Subject: Response to Correspondence 42591 for Certification of Transmitter with
FCC ID: AZ492FT3826, EA596340

FCC ID: AZ492FT3826

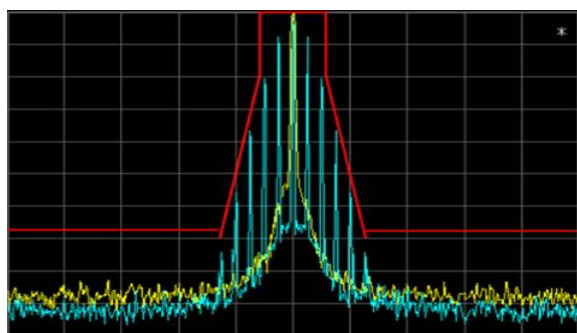
Q8. The measured power levels in the EMC report at high power mode (60/59.8/60 Watts) exceed the number provided on Form 731 (50 Watts).

R8. The power listed on the Form 731 is the Nominal or Rated Power which is 50 Watts. Also, the max power is 60 Watts and is usually listed in the FCC Grant Notes. Also, the Nominal Power meets the FCC's Rule Part 90.203 (r) requirement of 20%.
